Rev 3.0. **Changes from 2.2 are in bold type.**
10 October 2007

K1NQ, W1UE, KV1J and I have been looking over and building up some portions of the 6BPF boards and have come across some corrections that will need to be done before and as you build the boards. I've volunteered to put out the construction notes.

View of K8 solder pads from bottom side of board

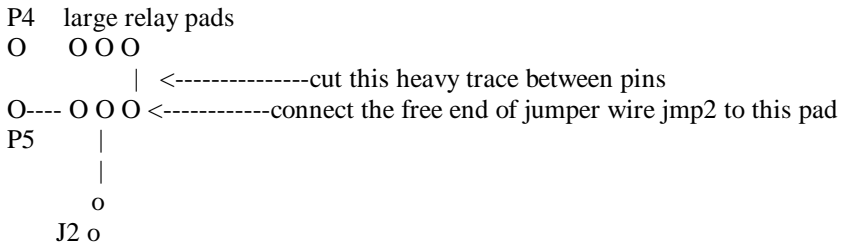
3- Jumper "jump2" needs correction. One side of it should go to the hole marked "jump2" near C56, but do not connect the other end to the hole marked "jump2" under K3. Instead this end of the wire needs to go to one of the pins of relay K8 as shown below. **Use a piece of hookup wire under the board for this, and not RG174.**

Also cut the trace shown.

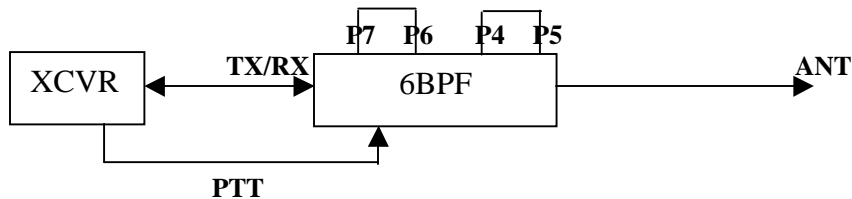
C. Bypass capacitors C67-C75 and C80-C86: the parts supplied have too narrow a lead spacing to fit the footprint in the board and need to be spread apart. Use a small needle nose plier to hold the lead when you bend it so as not to introduce small cracks in the seal of the ceramic body. Bend one lead as suggested below. Take care that the horizontal part of the bent lead does not short to any traces on the top of the board that go between the pads. This same technique should also be used for other caps having too close a lead spacing to fit the holes without straining the leads.

D. Capacitor C77 has the opposite problem to that above. Similarly bend one of its leads toward the other to shorten the spacing.

G. Wiring of Option Jumpers P3-P7:

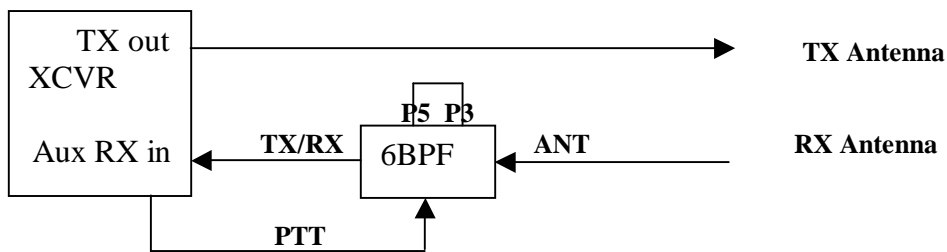
For using the filter with a radio that transmits and receives on the same connector (the usual situation), put a jumper between P7 and P6, and another between P4 and P5, and be sure to hook up a PTT signal to the filter. Keep the jumpers at least 1/8" away from other traces on the PCB. (And see K1NQ's warnings about the absolute necessity of using a PTT signal, and its delay requirement.) When you transmit, the TX/RX port of the 6BPF will then be switched directly to its ANT port, bypassing any selected filter section, but you must have proper PTT setup for that to happen.
